RENESAS TECHNICAL UPDATE

Product Category	MPU & MCU	Document No.	TN-RX*-A081A/E	Rev.	1.00
Title	Errata to RX63N Group, RX631 Group User's Manual regarding the RAM	Information Category	Technical Notification		
Applicable Product	RX63N Group, RX631 Group	Lot No.	Reference Document	RX63N Group, RX631 Group User's Manual: Hardware Rev.1.70 (R01UH0041EJ0170)	
		All

This document describes corrections to descriptions for the RAM in RX63N Group, RX631 Group User's Manual: Hardware Rev.1.70.

Figure 4.1 Memory Map in Each Operating Mode

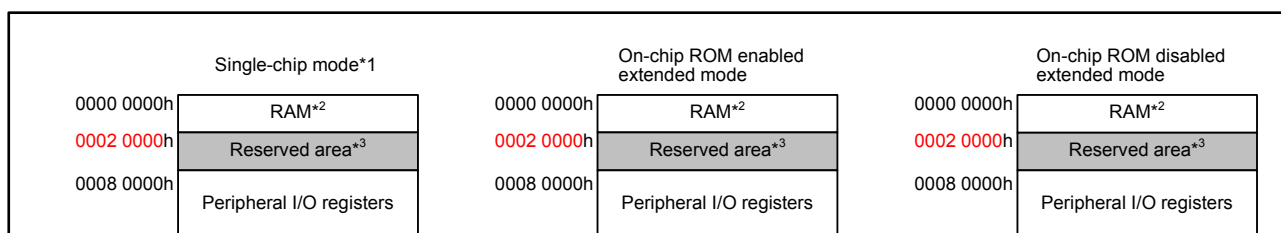
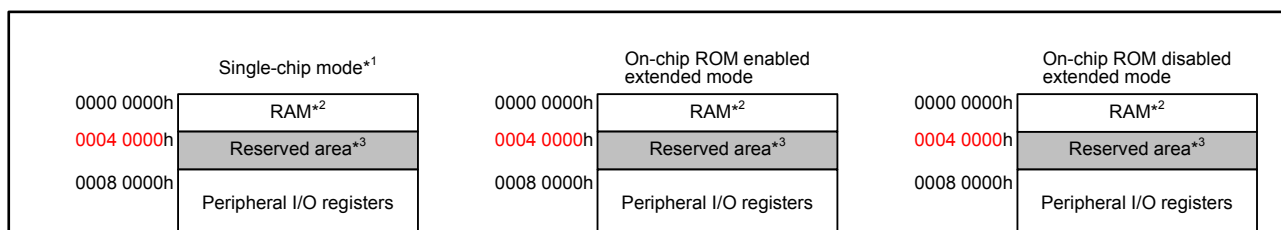
The address for the RAM in Figure 4.1 is corrected as follows:

**Figure 4.2 Correspondence between External Address Spaces and CS Areas
(In On-Chip ROM Disabled Extended Mode)**

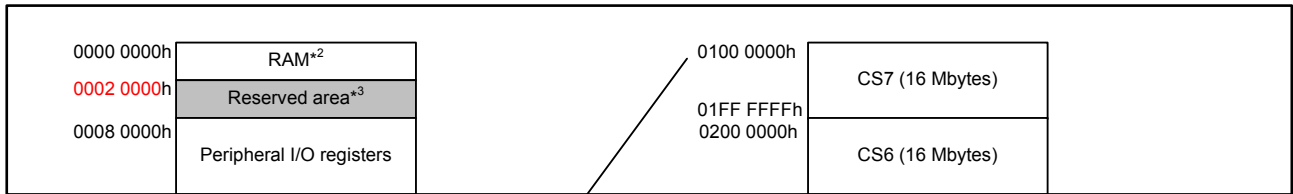
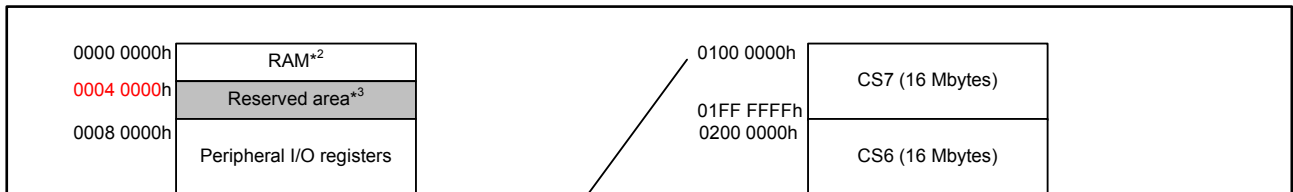
The address for the RAM in Figure 4.2 is corrected as follows:

Figure 49.1 Memory Map in On-chip ROM Disabled Extended Mode

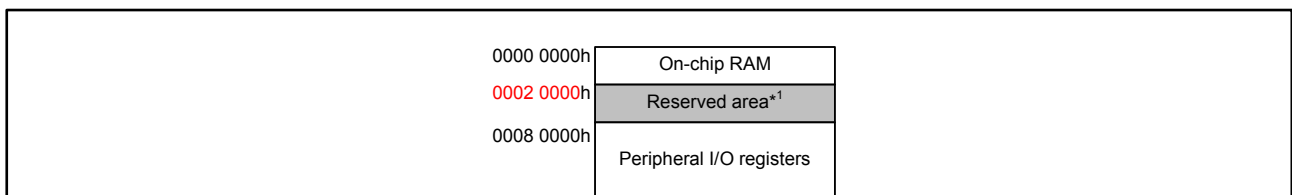
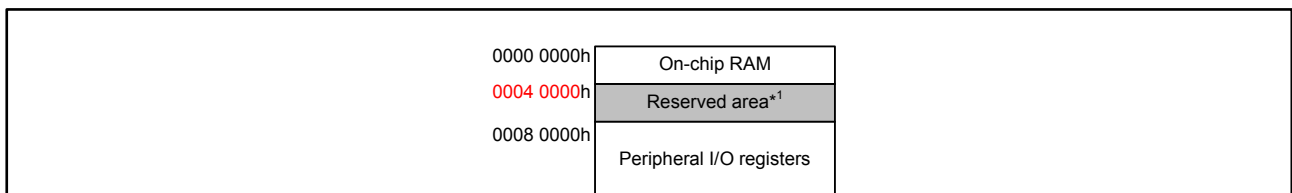
The address for the RAM in Figure 49.1 is corrected as follows:
